Product Change Notification: PCN-21-105956

PCN Date: 25-JUN-21

HDP SERIES, Plug & Receptacle, N and E Seal Configuration.

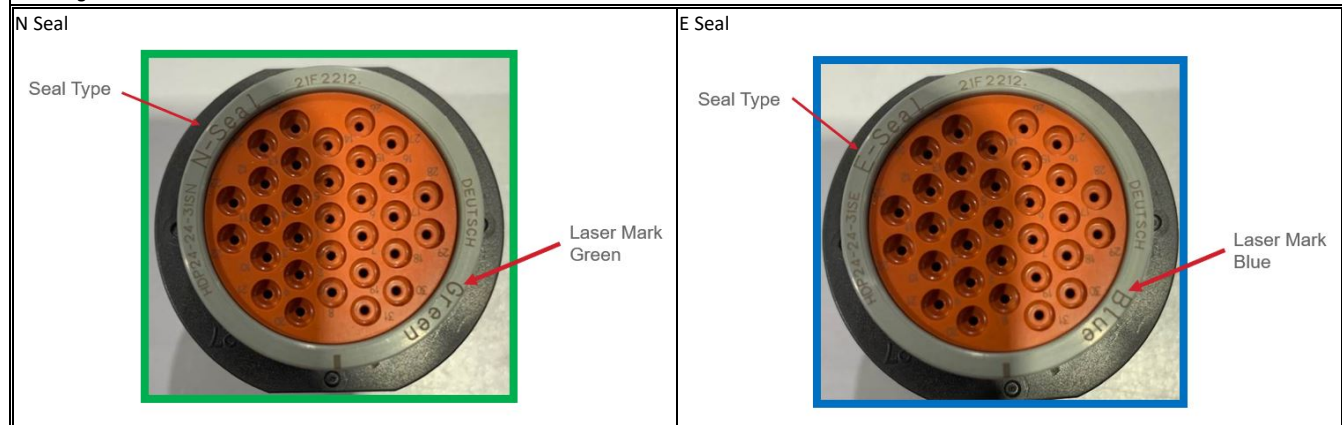
The Industrial and Commercial Transportation business unit of TE Connectivity is making a temporary (six months maximum) change to the color of the weld rings for the part number(s) listed below. Blue and Green weld rings, standard and all modifications: -L015, -L017, -L024, are going to be molded from gray material. A laser mark with the type of seal and the original ring color will be added to the connector. Blue or Green dot will be added to the box and Blue or Green colored sheet will be placed inside the box. With global demand in excess of supply on PA66, the material supplier is restricting TE's buying allotment on certain colors. These PNs are TE proprietary designs, therefore considered catalog/general market product. Product drawing(s) are not affected.
